Site Plan Review Committee (SPRC)
Staff Report for
1601 Fairfax Drive (Inn of Rosslyn)
SPLN22-00018 (SP #471)

1601 Fairfax Drive (Inn of Rosslyn)
SPLN22-00018 (SP #471)
(RPC# 17-027-008)

Proposed Ground Floor Plan:

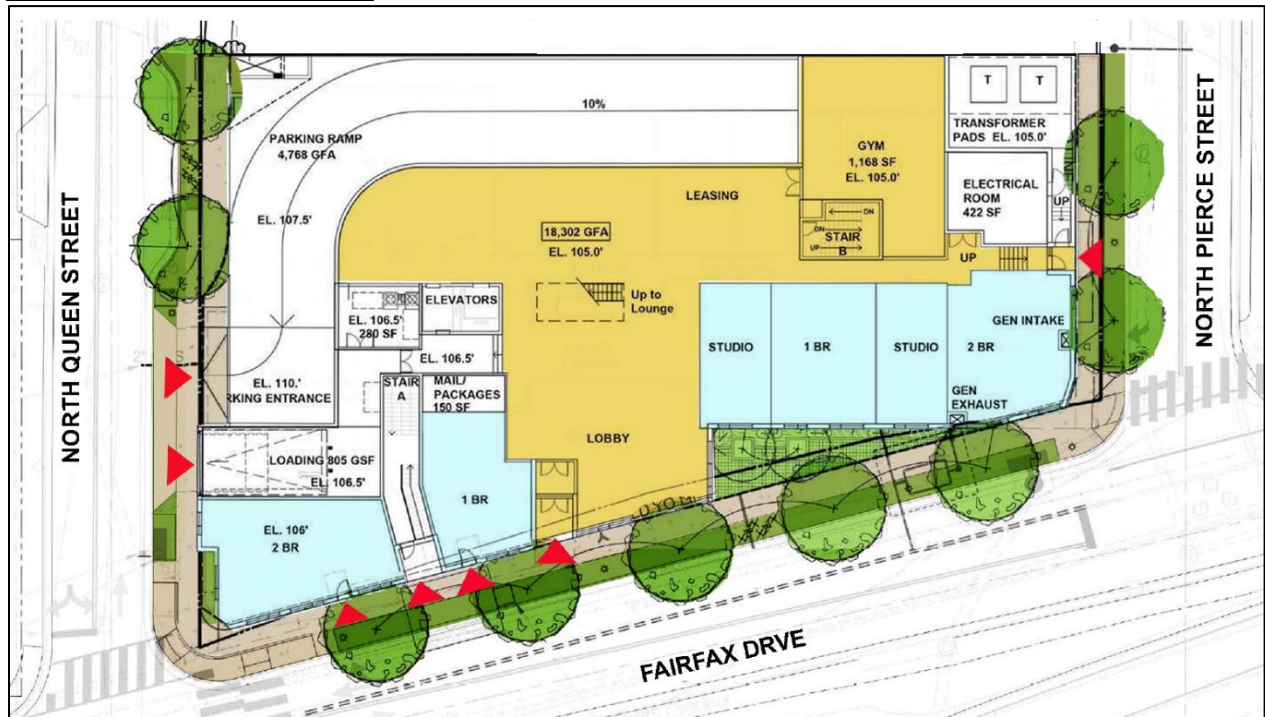
- The building podium along Fairfax Drive exceeds the property line, reducing the clear sidewalk width, and should be set back, without a notch, to provide a defined linear edge and appropriate eight-foot-clear sidewalk.
- The building footprint should be reduced to provide the recommended landscaped green space which is not currently provided. This space should mimic the style of the historic garden apartments.

Building Section (Looking West):

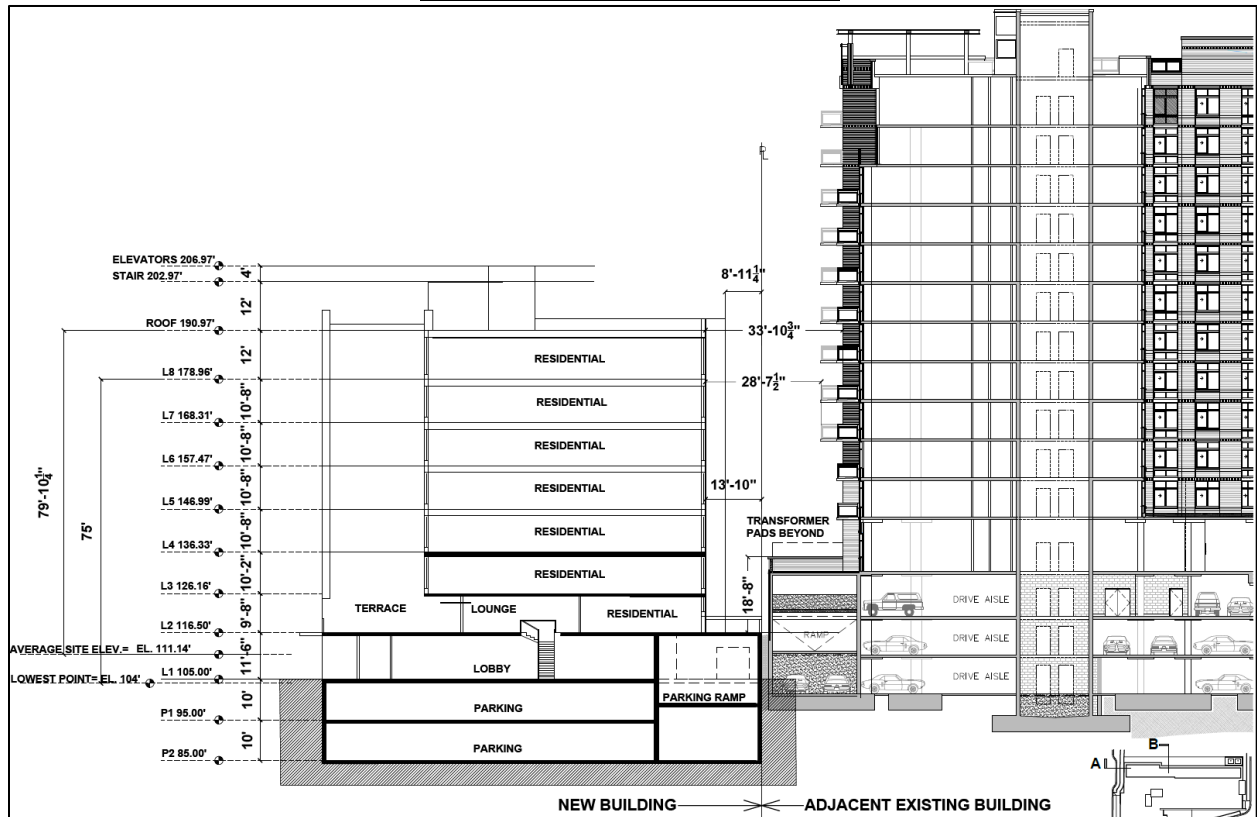
- Provide a 15-foot step-back at the fourth floor along Fairfax Drive. The proposed building overhangs the sidewalk and deviates from FMHNP guidance.
- Study adding floors (up to 12 stories total) in order to provide more appropriate building form and step-backs.
